Lilac Hills Ranch

Traffic Impact Study

**Roundabout Peer Review
Exhibit of Findings
October 2013**

Project Title:	W Lilac Rd Roundabouts	Design Phase (%):	Conceptual
Owner:	Accretive Investments, Inc.	Date:	October 25, 2013

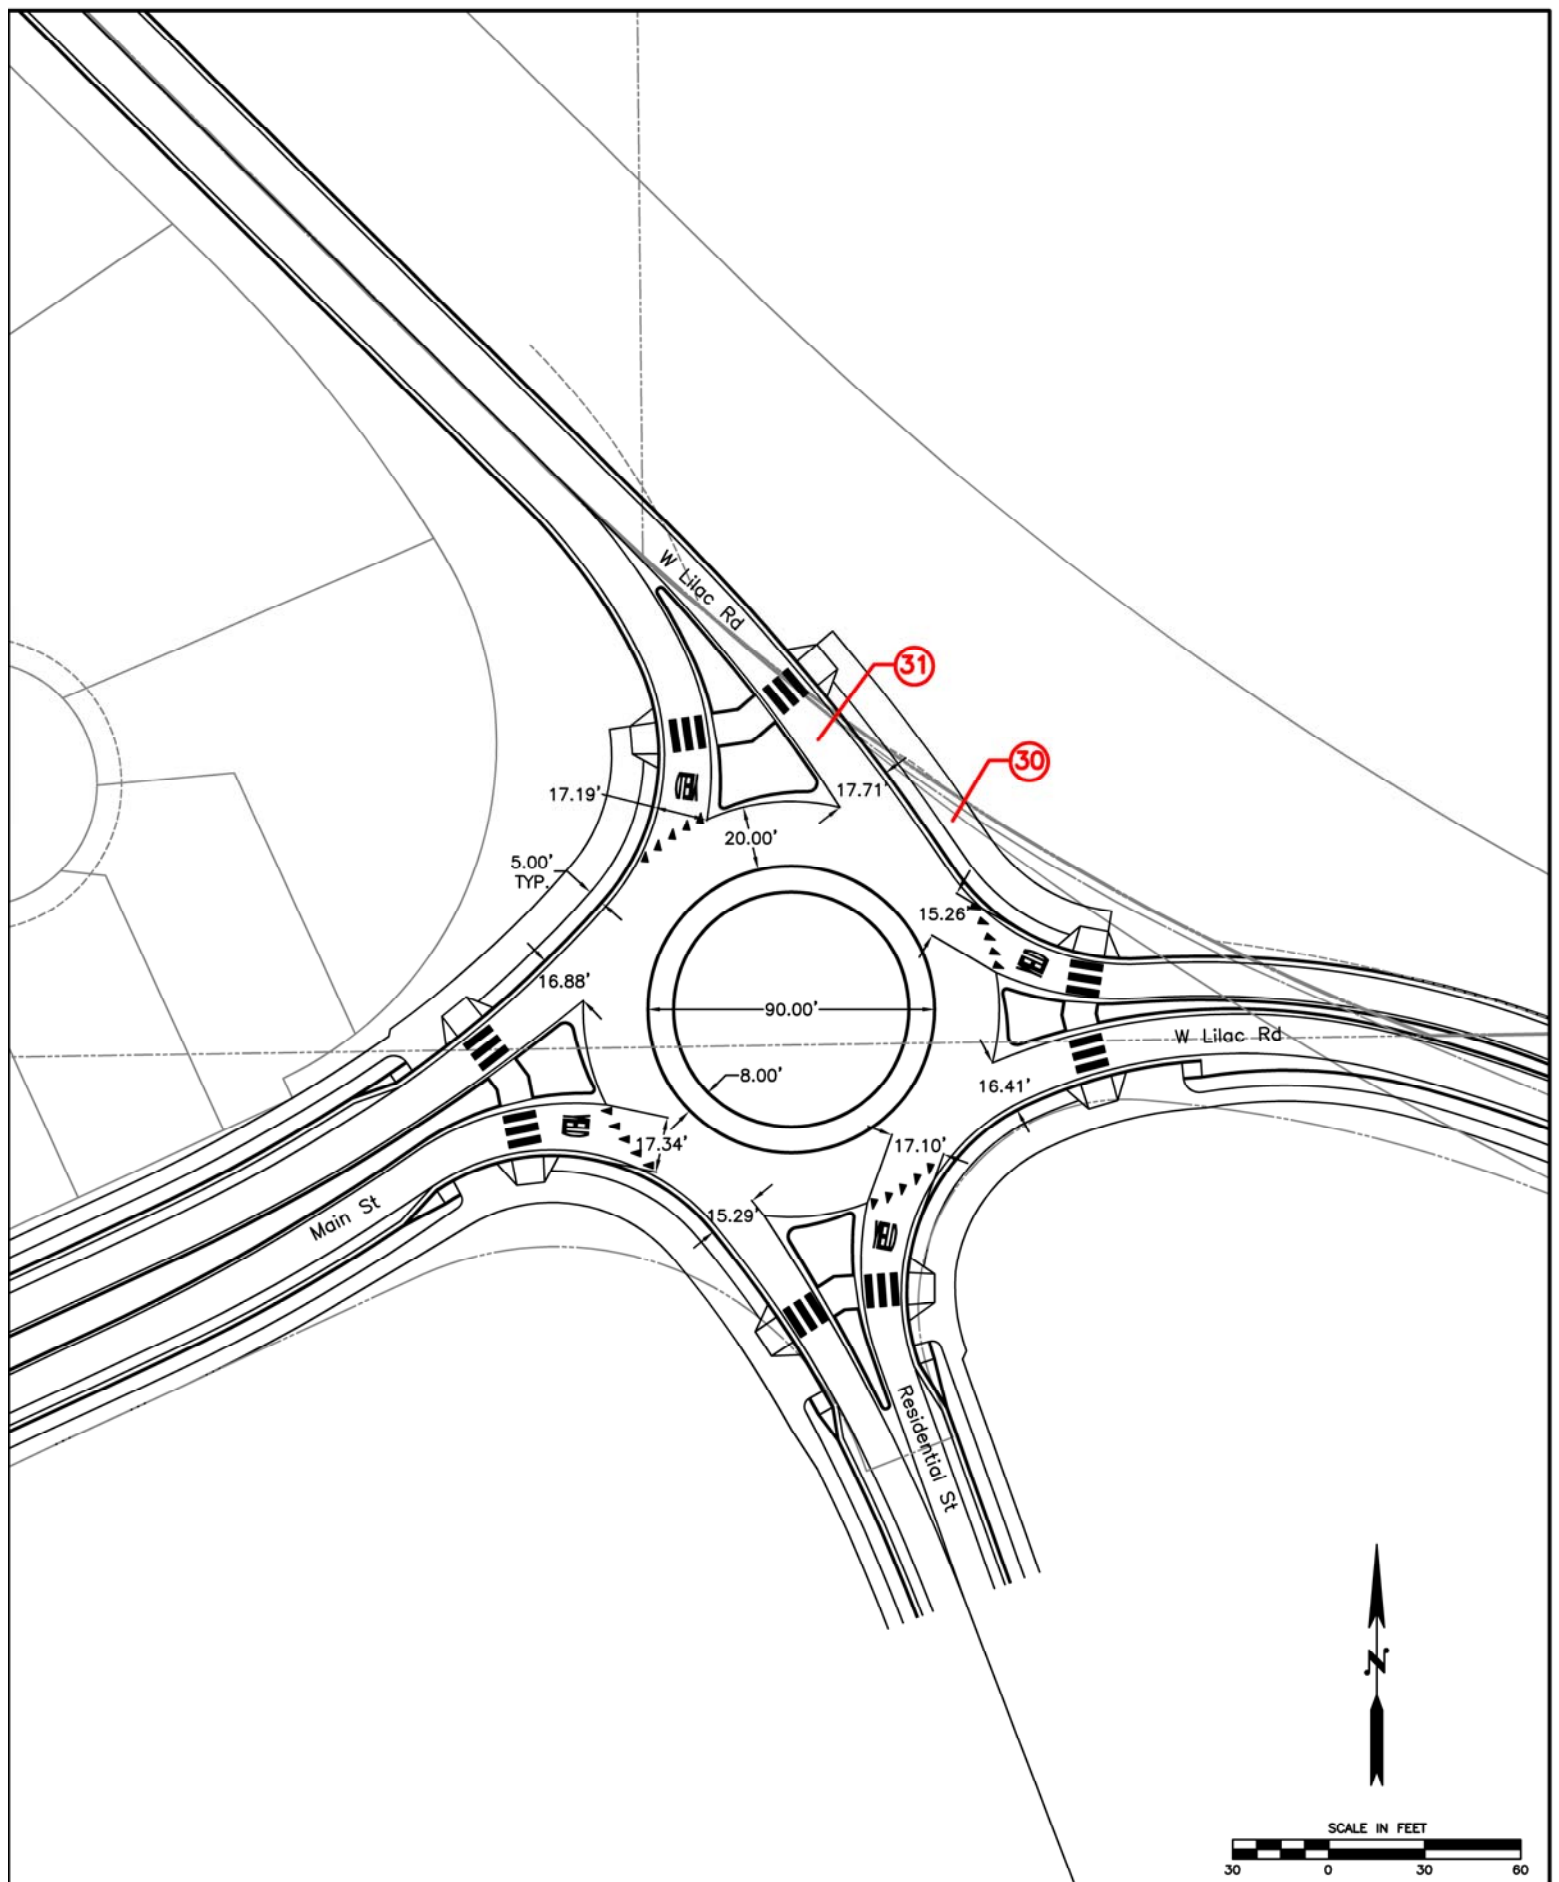
Item 30 (Figure 6)	Pedestrian facilities and corresponding crosswalk locations can be adjusted as needed based on proposed routes.
Item 31 (Figure 6)	Taking out the reverse curves on the W Lilac Rd exit (north leg) allows for a more natural vehicle path as cars exit the roundabout.
